SERVICE BULLETIN

Model: **40/45REZG and 40/45ERES (GM 4.3 L Engine)**

Subject: **Coolant Sensor Grounding**

Figure 1 Coolant Sensor Ground Wire

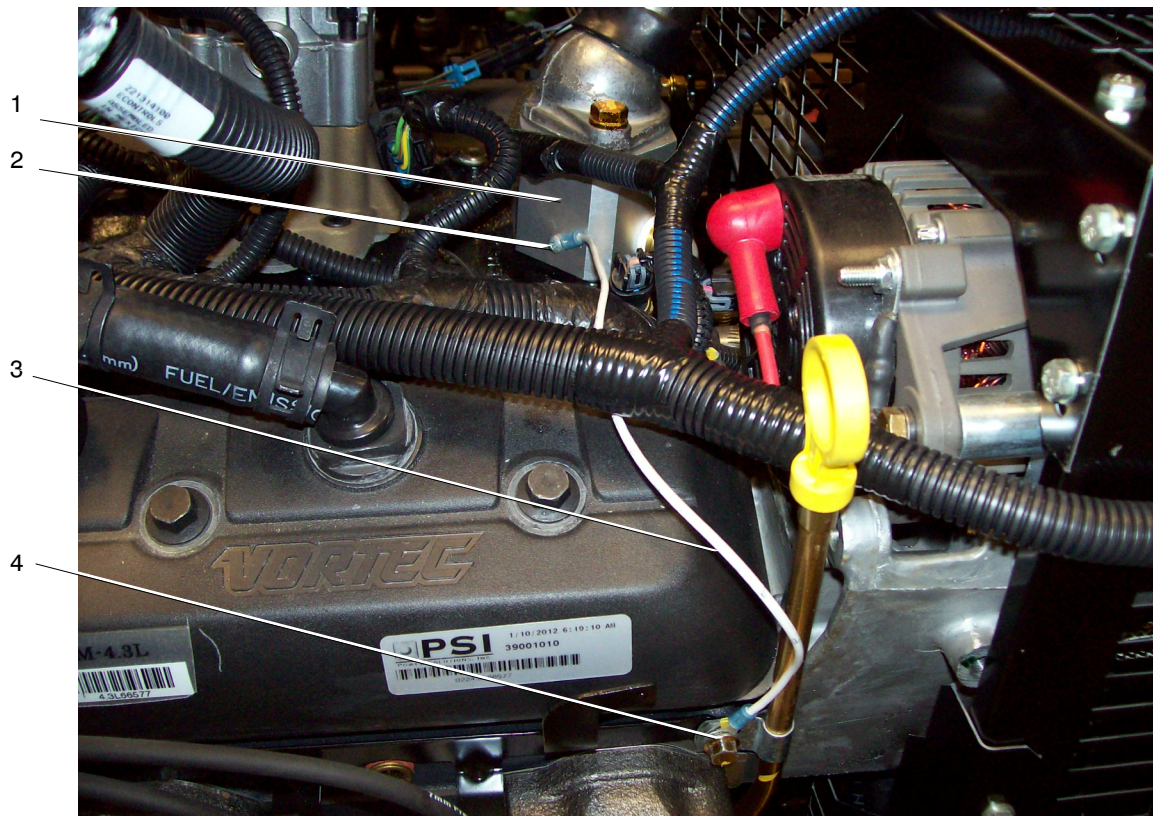
This service bulletin addresses 40/45REZG and 40/45ERES generator sets with serial numbers between 2322607 and 3034129. Generator sets built during this period may experience coolant temperature warning and shutdown faults attributed to the coolant sensor not having a proper ground to the engine block. This bulletin provides instructions on how to provide a sufficient electrical ground to the coolant sensor.

3. Install the ground wire to the engine. Refer to Figure 1.

- 3.1 Remove the bolt securing the oil dipstick tube, place the 1/4 in. ring terminal on the bolt, and reinstall the bolt.
- 3.2 Use a #8-32 screw (technician-supplied) to attach the #8 ring terminal to the coolant sensor.
